Technical Service Bulletin

46 Q7 MY18 Squeal from front brakes

46 18 01 2050737/6 November 21, 2018. Supersedes Technical Service Bulletin Group 46 number 18-96 dated September 4, 2018 for reasons listed below.

Model(s)	Year	VIN Range	Vehicle-Specific Equipment
Q7	2018	000001 - 039706	With disc brakes in front

Figure 1. Caliper casting lip configurations.

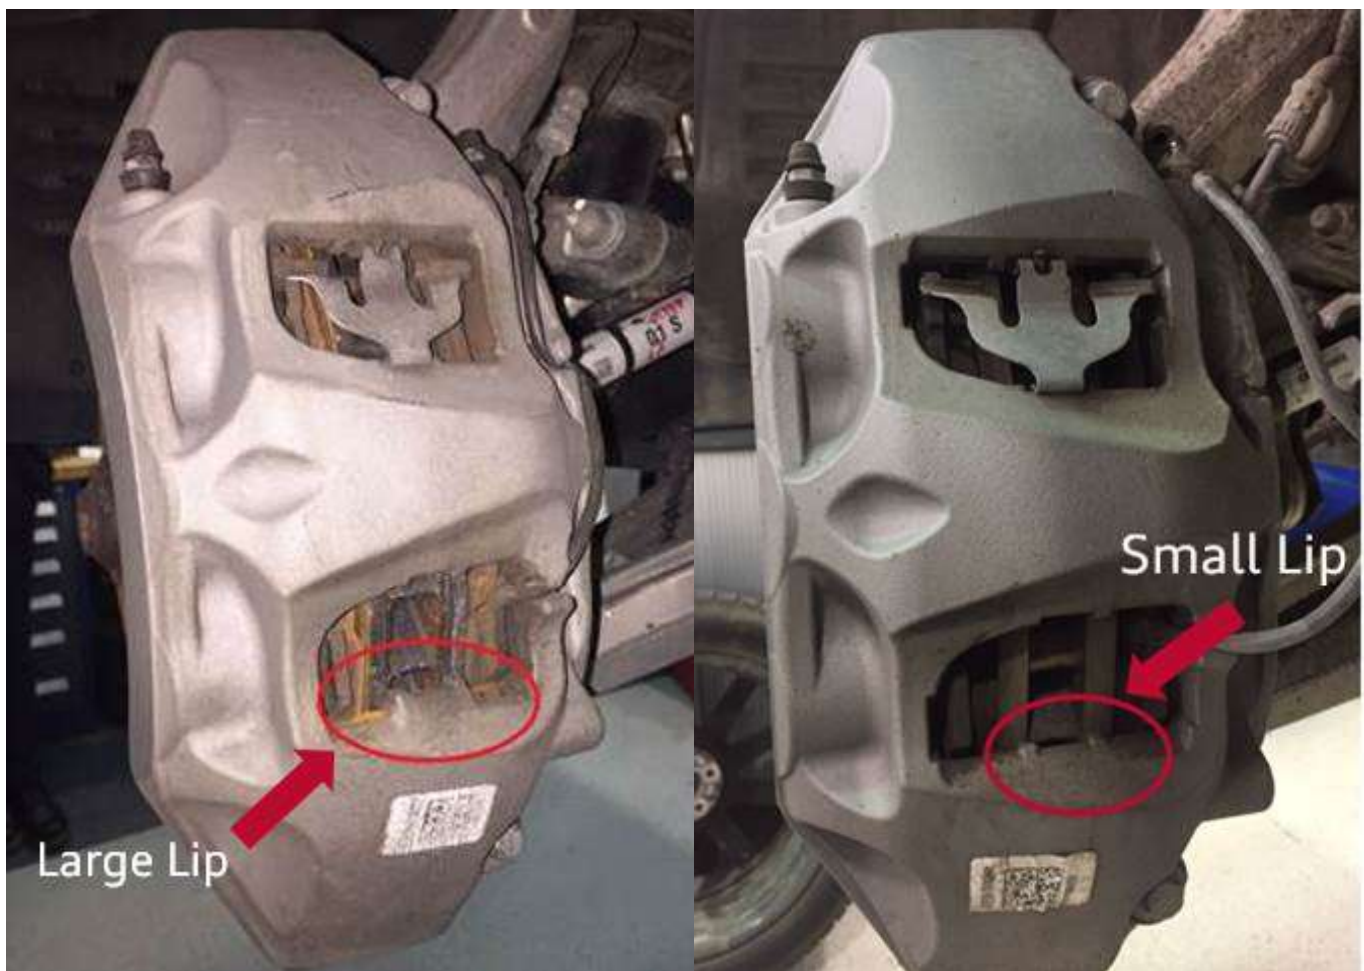
1. Identify the caliper casting lip of the installed caliper in the vehicle. There are two possibilities for the lip; large and small. (Figure 1).

Figure 2. Spring configuration, after installation.

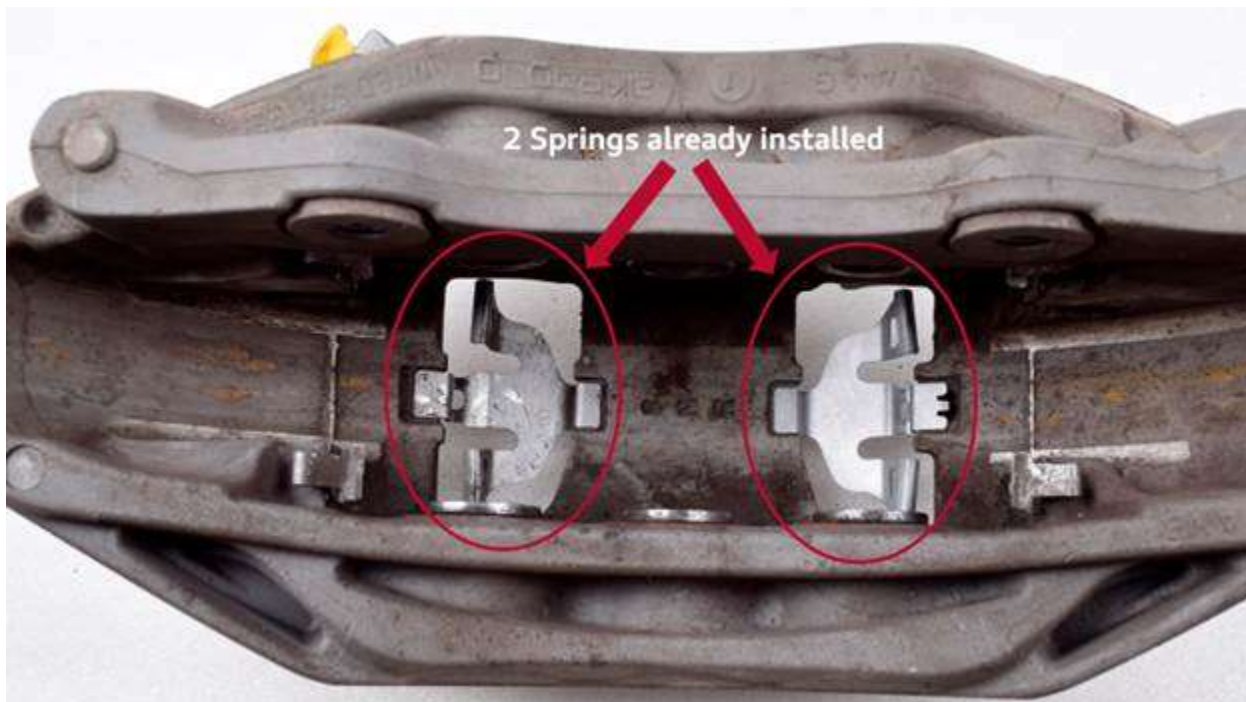
2. Install one new lower spring in each caliper. Final configuration must have two springs per caliper (Figure 2). See available spring designs (Figure 3).

3. According to caliper casting, a specific type of spring must be assembled, as follows:

LARGE CASTING LIP >>> INSTALL SPRING 4M0 615 269 C

SMALL CASTING LIP >>> INSTALL SPRING 4M0 615 269 or 4M0 615 269 B

Figure 4. Clean contact surfaces and then coat with lithium grease.

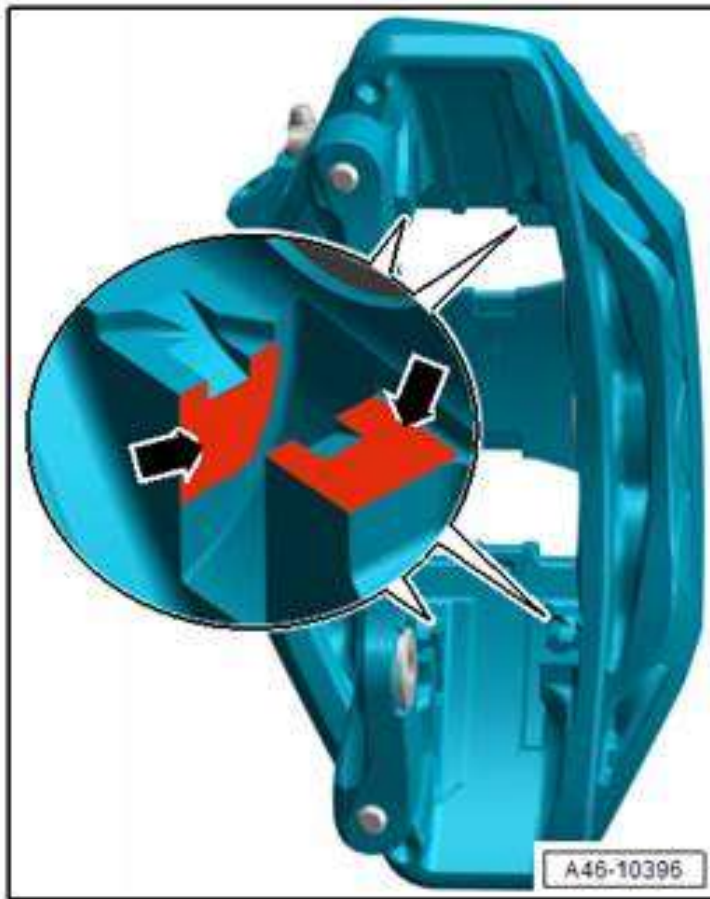
4. It is mandatory to clean the contact surfaces (red marked with arrows) and coat with lithium grease (Figure 4). Also, coat the brake pad plate/guide pins and pad contact surfaces with lithium grease.

Figure 5. Correct installation positioning for the brake pad.

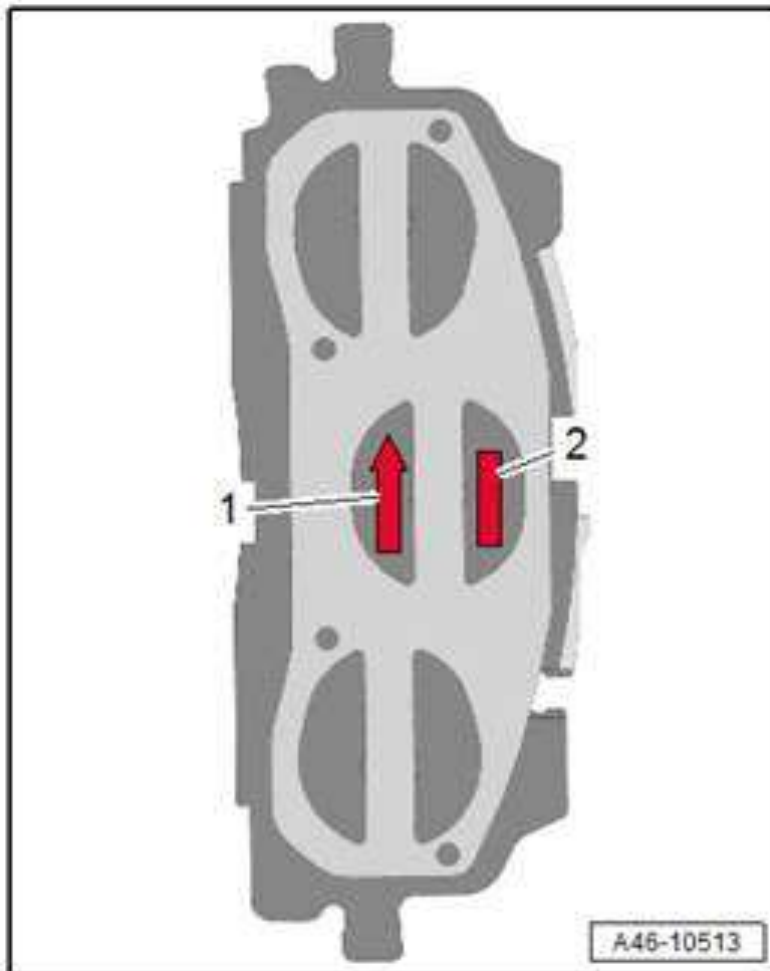
5. It is mandatory to pay attention to the labeling on the brake pad (Figure 5). In installed position the arrow (1) on the backing plate must point upward (the pads should be installed with the arrows following the forward rotation of the wheel). Labeling (2) indicate correct assembly position (left outer/inner, right outer/inner).

Figure 6. Replace all 4 intermediate plates.

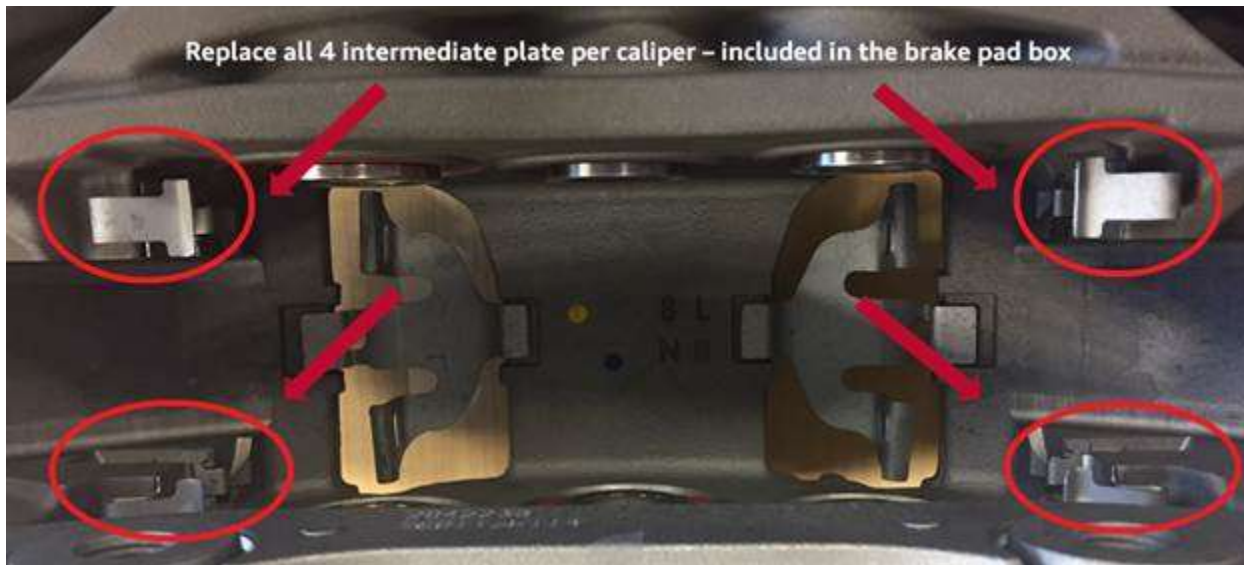
6. It is mandatory to replace all 4 brake pad intermediate plate per caliper – included in the brake pad box (Figure 6).
